INITIAL FIRE SAFETY INSPECTION REPORT

ULTIMATE FASHIONS LIMITED (EXTENSION)

RSC ID: 25994

Fire Safety Inspection Report

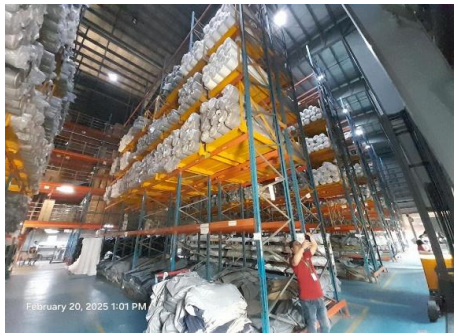
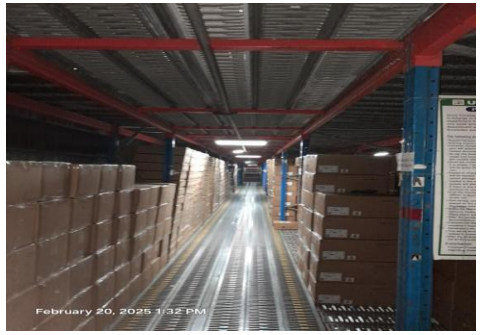
Sl No.	Category	Findings	Required Action	Remediation Time Frame
F-01	Fire Rated Construction	Rooms used for combustible storage are not separated by fire rated construction. Locations: Ground floor (Jhut Boiler Shed), Idle machine room (Multipurpose Shed).	Rooms used for storage of combustible materials shall be separated from the surrounding occupancy with a minimum 1 hour construction in accordance with section 3.4.2.1.5 of RSC Technical Guideline (Standard).	Within 3 months

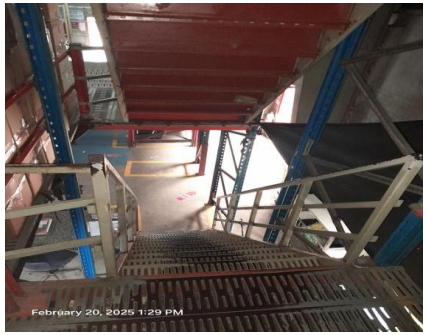
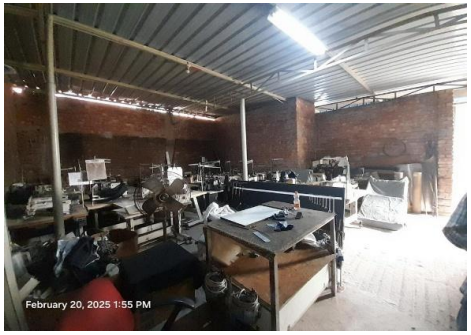
F-04	Means of Egress	The exit stair enclosures are not separated from work areas and other spaces on each floor by fire-rated construction. Location: Warehouse Rack Shed (Exit stairs from mezzanine floors).	The exit stair enclosure shall be provided with a minimum 1-hr fire resistance rating for buildings with 3 or fewer stories and a minimum of 2- hr. fire resistance rating for buildings 4 or more stories. Provide 1-hr. fire rated door and seal all penetrations and openings by 1 hr. fire rated fire rated barrier construction for building with 3 or fewer stories. Provide 1.5 hr. fire rated door and seal all penetrations and openings by 2 hr. fire rated fire rated barrier construction for building with 4 or more stories in accordance with section 6.3.1.2 of RSC Technical Guidelines (Standard)[1] V1.0. Provide a fire-resistive rated assembly between the exterior exit stairs and the building up to 10 ft. beyond the end of the stair to achieve the required separation. The rated assembly shall be approved and/or designed by a qualified fire protection engineer. Ensure that the fire doors are self-closing and positive latching and that they are provided with fire exit (panic) hardware where serving production floors. If fire doors are required to be held open for functional reasons, provide automatic closing devices tied to the fire alarm system.	Within 3 months

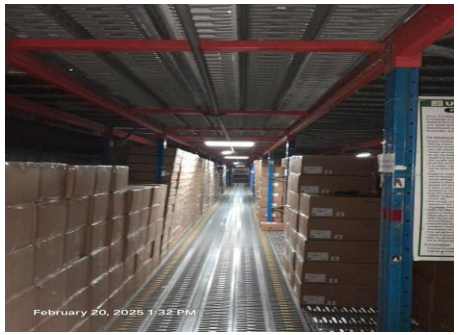
F-05	Fire Rated Construction	A catwalk (deck) has been constructed on the high-rack storage, and the area of the intermediate deck creates a separate floor, as the size of the decks exceeds 33% of the total floor area, requiring fire-rated separation. Location: Warehouse Rack Shed.	Remove the catwalk of the intermediate deck. Or , The floor must adhere to the RSC building standards and BNBC 2006 regulations regarding fire rated construction and egress features.	Within 3 months
